Re: 35 Rice Street, Wellesley, MA LHR-20-05

Please see replies to engineer's memo dated December 10, 2020 with subsequent highlights and comments from Engineering.

Memo Don McCauley
December 10, 2020

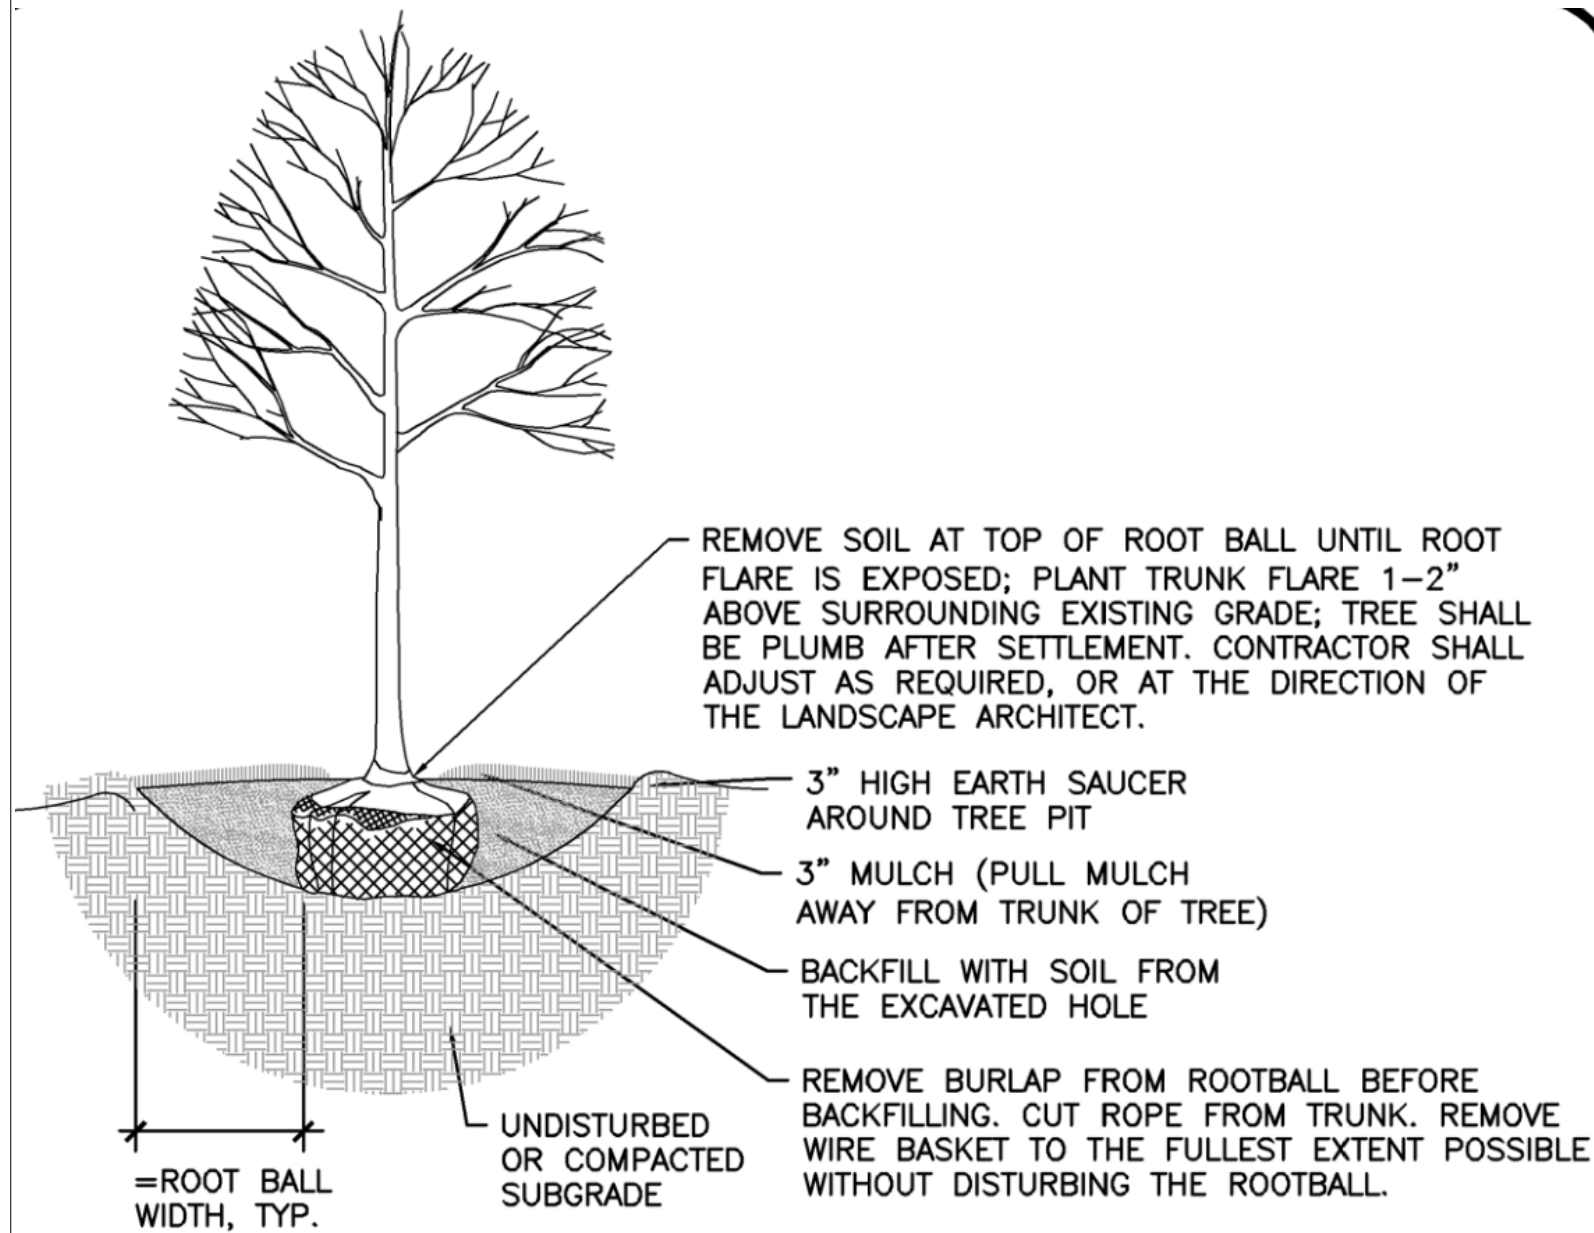
- The proposed curb cuts for the circular driveway will require a Street Occupancy Permit with the DPW. The plans should provide a cross section of the proposed driveways within the Rice Street layout. The driveways appear to be single width driveways and are spaced 20 feet apart as required by the Town of Wellesley Policy Governing Driveway Aprons and Curb Cuts. Provide dimensions for the proposed bituminous concrete driveway, especially at the street line of Rice Street.

- ◆ The width of the driveway as it crosses the property line is 13'-0" wide. We have included a dimensioned sketch as part of this memo reply. This memo reply is also being provided to the Planning Department for proper filing protocol.

PLANTING DETAILS

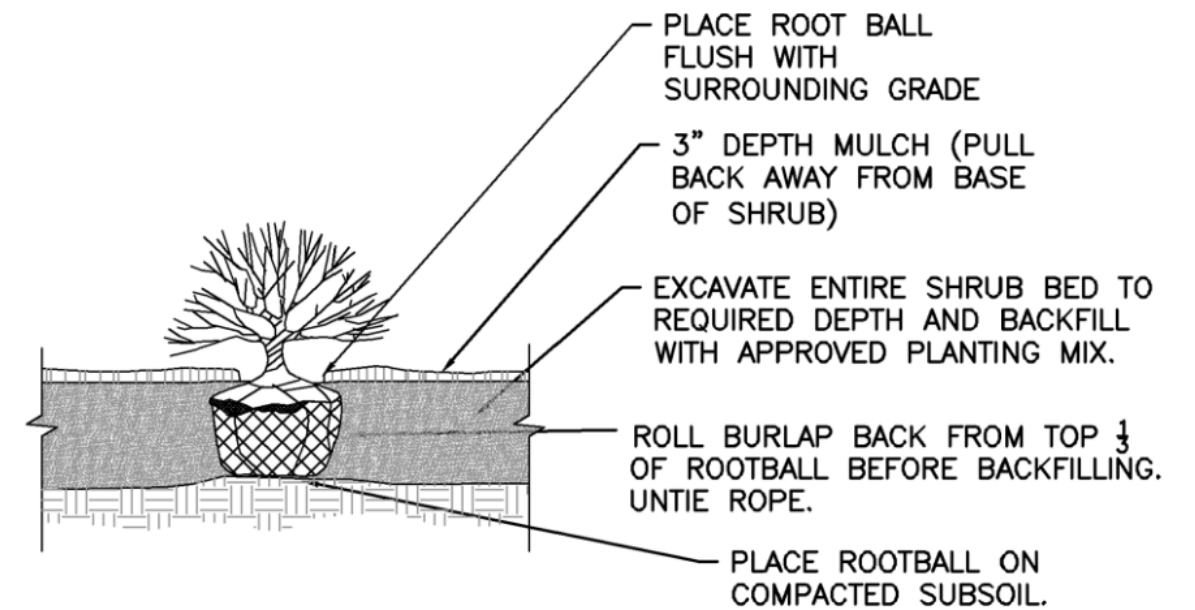
- The plans should include details for shrub and tree planting as well as tree protection details.

- ◆ Please see attached details for tree and shrub plantings and the tree protection details on the revised plans.
